Re: Freddy's

131 Coors Blvd NW

Requested for 60-Day Permanent C. O. - Accepted

RE: Freddy's (Formerly "Whataburger"), 111 Coors Blvd. NW Grading and Drainage Plan Engineer's Stamp Date 6-03-2015 (File: K10-D001B)

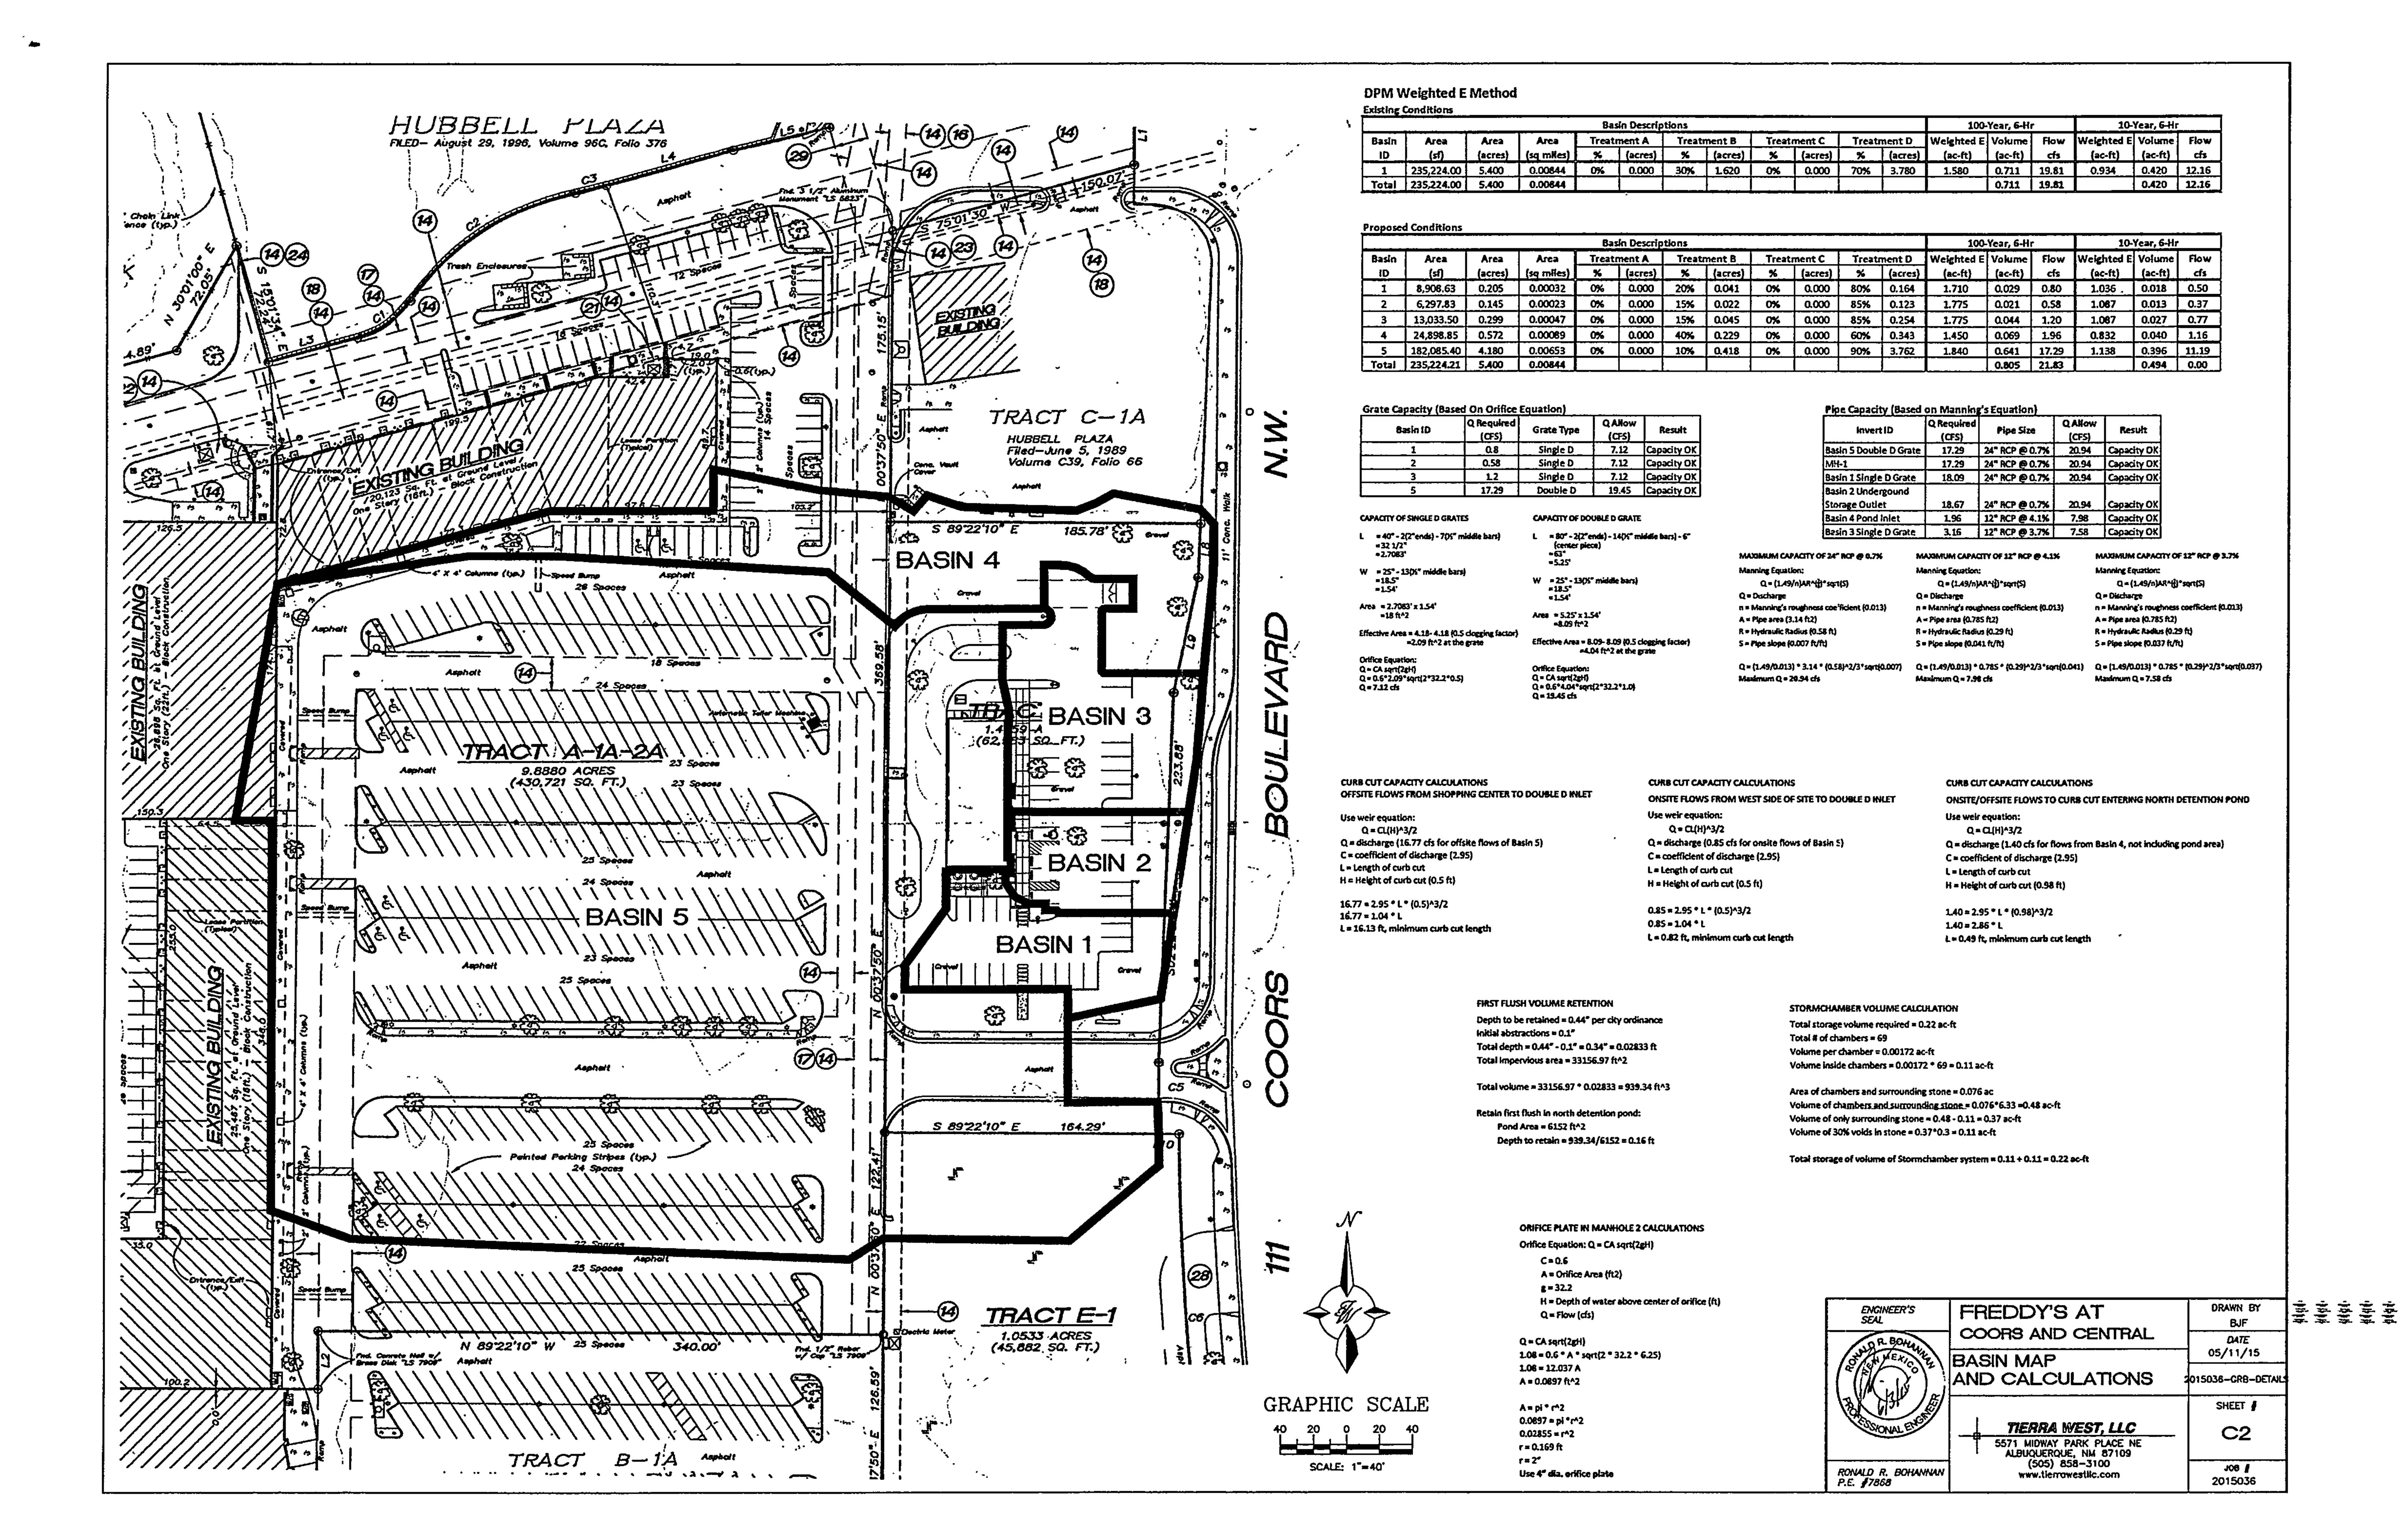
- 1. The volume of on-site storage detention is shown to be based on the 100-year 6-hour storm event. Provide a hydrograph which shows that 90% of the storage volume will be discharged from the site within 6 hours, as per Drainage Ordinance. Response: An AHYMO hydrograph was provided to your office with the COA at an earlier date showing the amount of time to discharge the runoff from the site. A letter from you, dated 3/24/2015, shows approval for action by EPC, this letter is approval for addressing the hydrograph request.

- 2. On the plan view for the "Grading and Drainage Plan", label all of the different detention volumes that correspond to the "Proposed Conditions" discussion which include the 0.43 ac-ft. detention pond, the 0.16 ac-ft surface pond, and underground storage of 0.22 ac-ft. Show the underground storage system area on the plan view for the "Grading and Drainage Plan", and label the connections from the new 24-inch storm drain two this underground storage system.

- 3. There is a Section A-A on the "Grading and Drainage Plan" which shows pond elevations within the detention pond in the north area of the site. Provide more spot elevations within this area at the corners of the pond to ensure that there will be enough volume provided for the detention pond.

- 5. How is storm drainage getting to the Double-D inlet on the west side of the site? Provide capacity calculations for the 5.6-foot wide curb cut that is accepting the offsite flow from the west and adjust as necessary.

- 6. Provide capacity calculations for all of the curb cuts shown on the plan.
- Response: All curb cut calculations were added to the "Basin Map and Calculation's" sheet. These calculations are for 3 different curb cut areas: the length of cut accepting the offsite flows, the length of cut accepting flows from west side of site, and the cut accepting flows from Basin 4 into the detention pond.

- 7. A summary table is provided for grate capacities and pipe capacities on the "Basin Map and Calculations" sheet. Please provide the calculations for these capacities. Response: The calculations for the grate capacities and pipe capacities were added to the "Basin Map and Calculations "sheet.

Response: The detention volumes for surface ponding and the detention pond have changed slightly and were accounted for in the narrative discussion and calculations, still equating to the total 0.81 ac-ft of total storage. Detention volumes were added to each label calling out the maximum water surface elevations for the surface and detention ponding areas. The two surface ponding areas show ponding areas show 0.08 ac-ft and 0.15 ac-ft volumes for each, equating to the total 0.23 ac-ft for surface ponding. The north detention pond shows the volume to be 0.36 ac-ft. The underground storage system was hatched and called out on the "Grading and Drainage Plan" Sheet, the detention volume was added to this label as well (0.22 ac-ft). The two 24-inch storm drains that connect to the underground storage were labeled and show the invert elevations of where each connects.

- Response: Top of Wall and Bottom of Wall spot elevations are called out at the corners of the north area detention pond on the "Grading and Drainage Plan" sheet.

- Response: Storm drainage on the west side of the building/site is directed towards the landscaped area, away from the building. This drainage is directed towards the Double D inlet through a series of 1 foot curb cuts along the east curb of this landscaped area, the locations of the cuts are marked on the Grading and Drainage Plan" sheet as keyed note 7. Capacity calculations for the curb cut accepting offsite flows from the west were added to the "Basin Map and Calculations" sheet. For the given offsite flows, the curb cut width needs to be 16.2 feet wide. The grading plan was modified for this change and concrete bollards were added within the curb cut to prevent vehicles from entering.

- The length of cut needed for the entire flows on the west side of site is 0.49 ft. The slope of the curb where this drainage would cross is relatively flat; therefore the series of 1-ft curb cuts are added to ensure that all drainage from this area can reach the double D inlet.

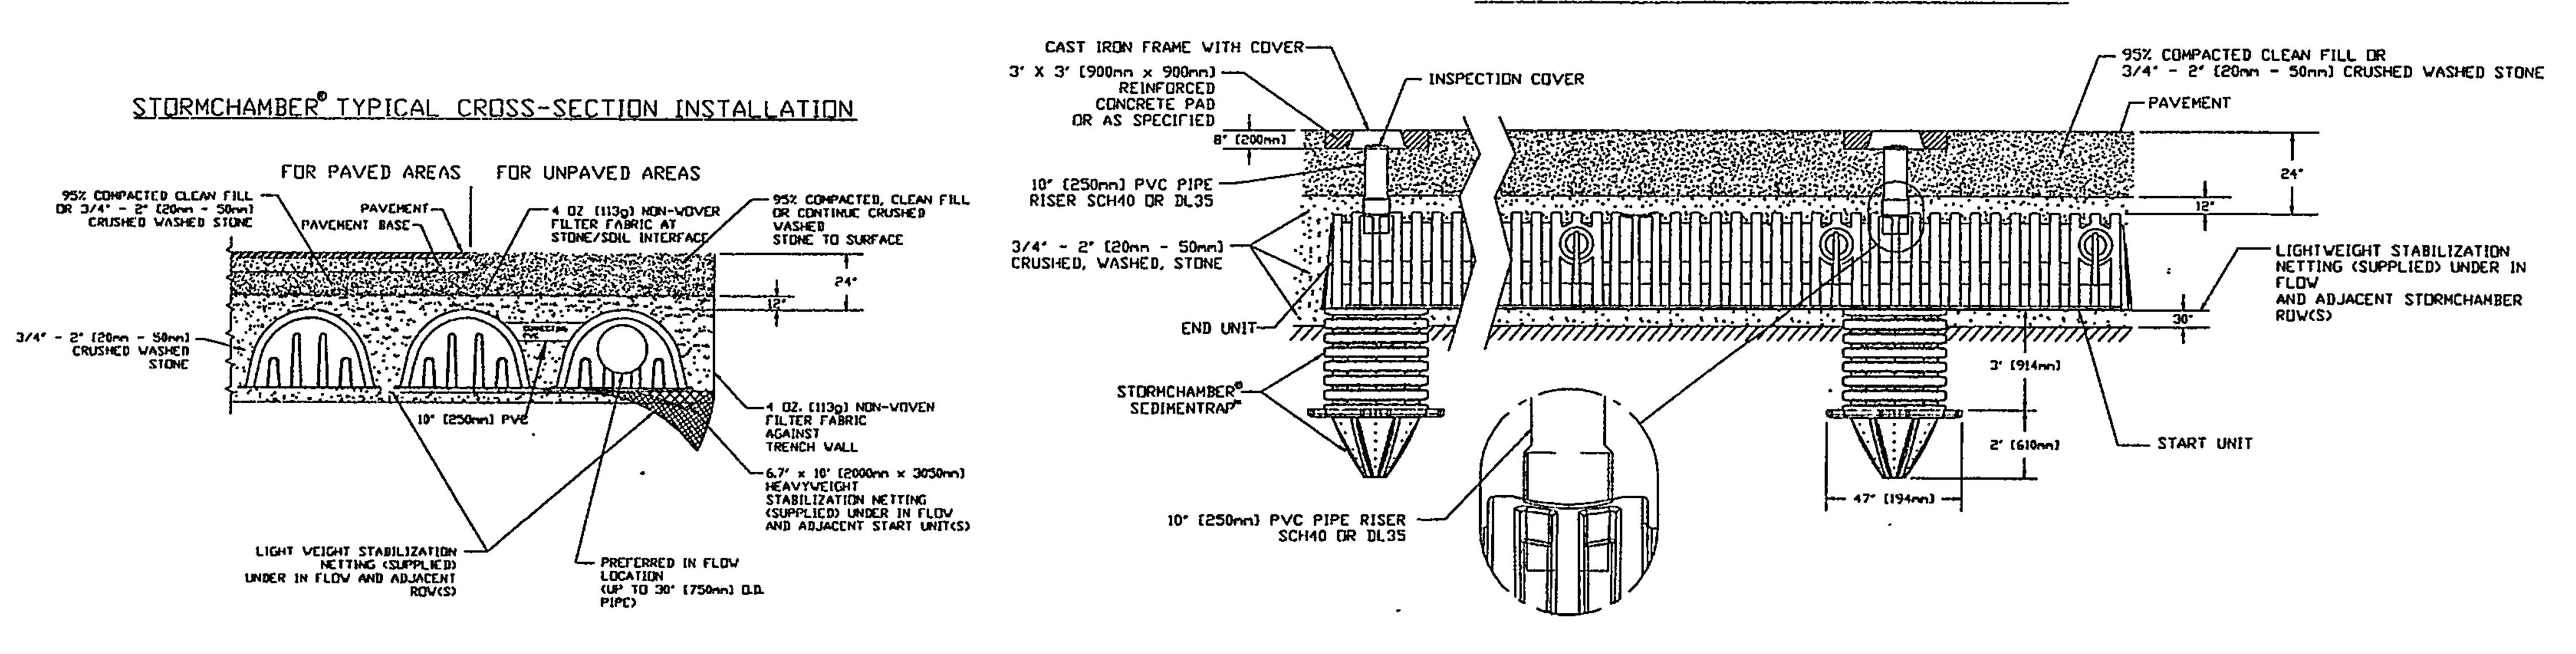
- 9. The number of chambers shown on the "Basin Map and Calculations" sheet is 75. This needs to be called out on the plan view detail on the "Stormchamber Storage System" sheet to make sure right number of stormchambers will be installed. Also, please provide a legible table showing the dimensions for the stormchambers. Response: The number of chambers was reduced from 75 to 69. This was modified in the Stormchamber volume calculations and is called out on the plan view detail on the "Stormchamber Storage System" sheet. The table showing the material quantities and the cross sections of the chambers was modified to be more legible.
